From: Melissa Rassack
Sent: Wednesday, 28 July 2021 9:05 AM
To: Bianca Thornton; William Hodgkinson
Cc: Liza Miller
Subject: RE: SSD-23480429 - 253-267 ALDINGTON ROAD, KEMPS CREEK

Response to Request for Advice on SEAR's Request: 253 - 267 Aldington Road Estate Warehouse and Distribution Use - SSD-23480429

Figure 1: Pre-Development Development Scale Flow Duration Curve (refer spreadsheet attached)

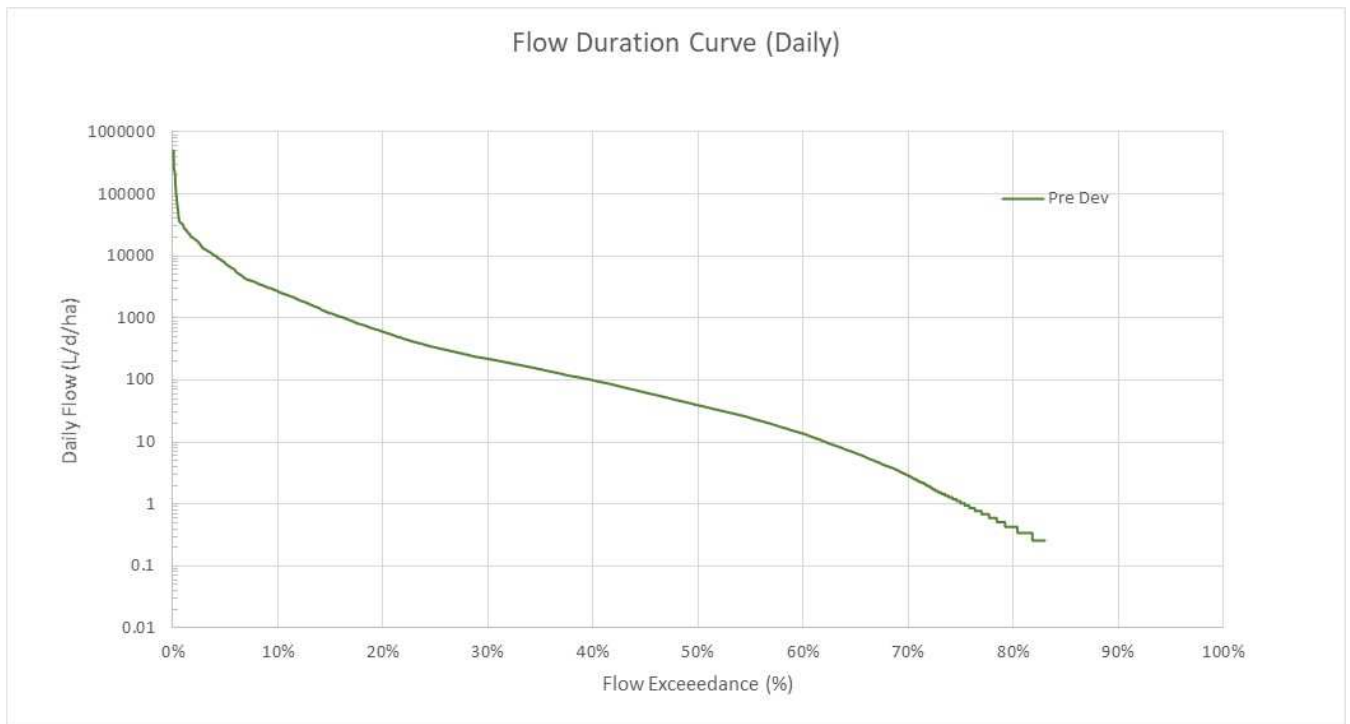
Note: Flexibility for showing compliance with the performance criteria has been provided in response to feedback from the urban development industry. Option 1 is primarily based on MARV and is simpler to calculate using industry standard models, whereas Option 2 is based on key percentiles of a flow duration curve. Development must comply with either Option 1 or Option 2.

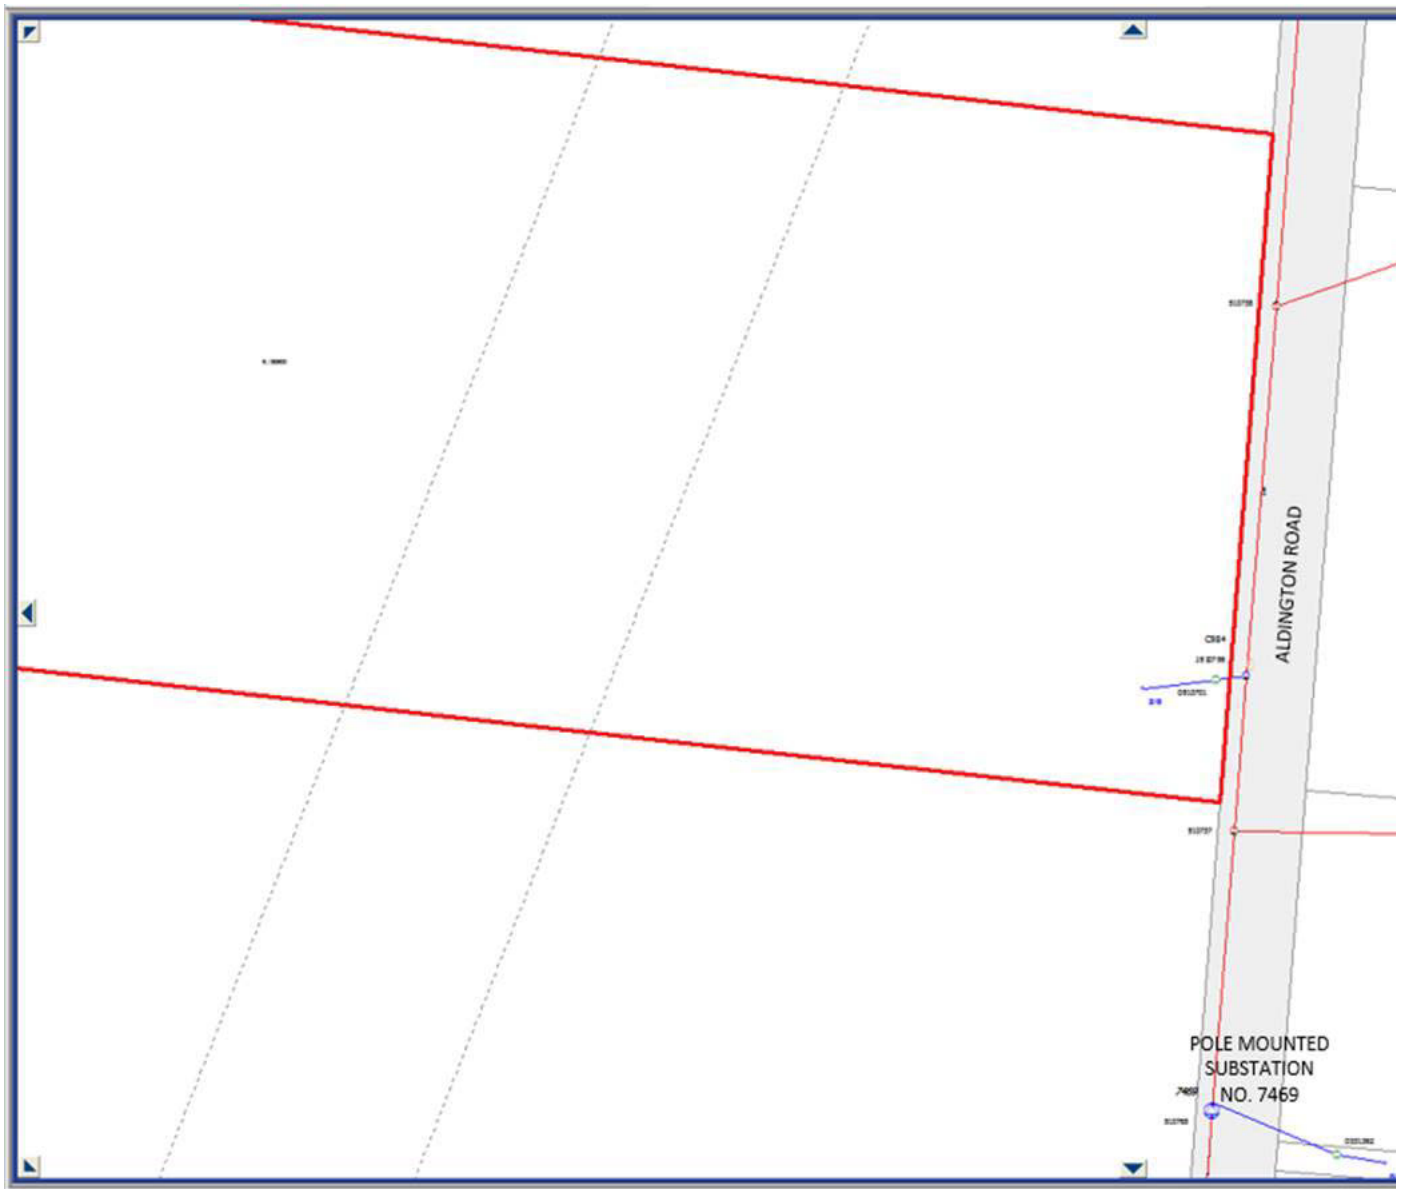
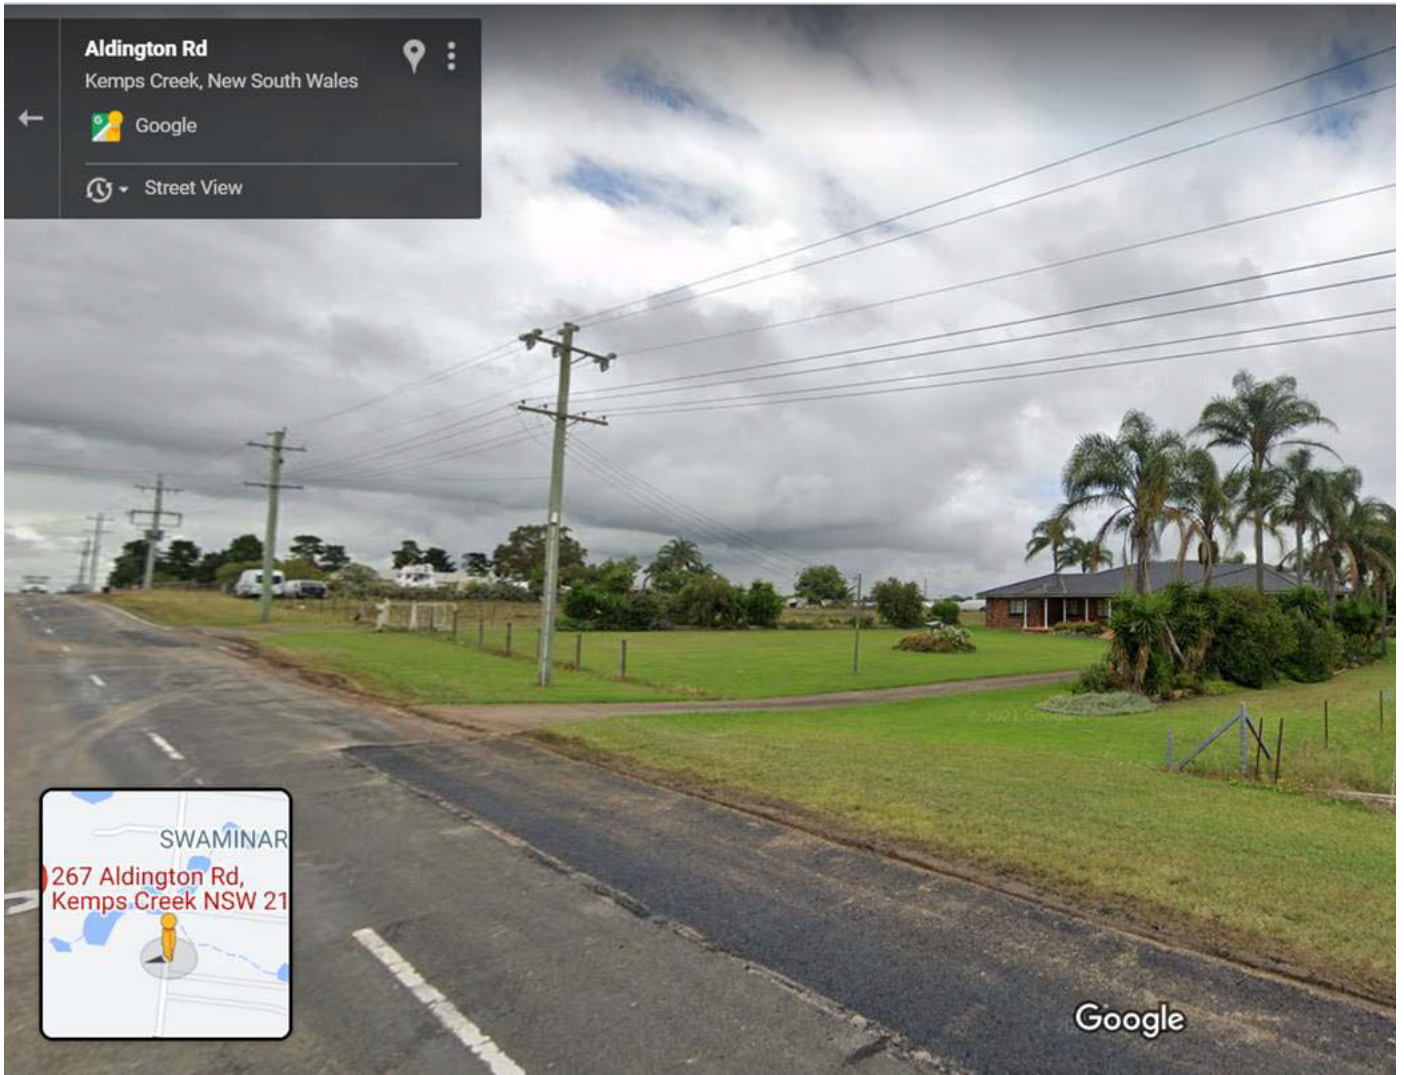
As shown in the below site plans from Endeavour Energy's G/Net master facility model (and extract from Google Maps Street View) there are:

Endeavour Energy's G/Net master facility model does not show electricity infrastructure belonging to other authorities. The black dashed lines indicate that there is an easement for overhead power lines for a voltage in excess of the 132,000 volts / 132kV that are not part of Endeavour Energy's distribution network but are part of the high voltage electricity transmission network owned and operated by TransGrid. Endeavour Energy has noted from the SEARs Scoping Report the applicant has already engaged with TransGrid.
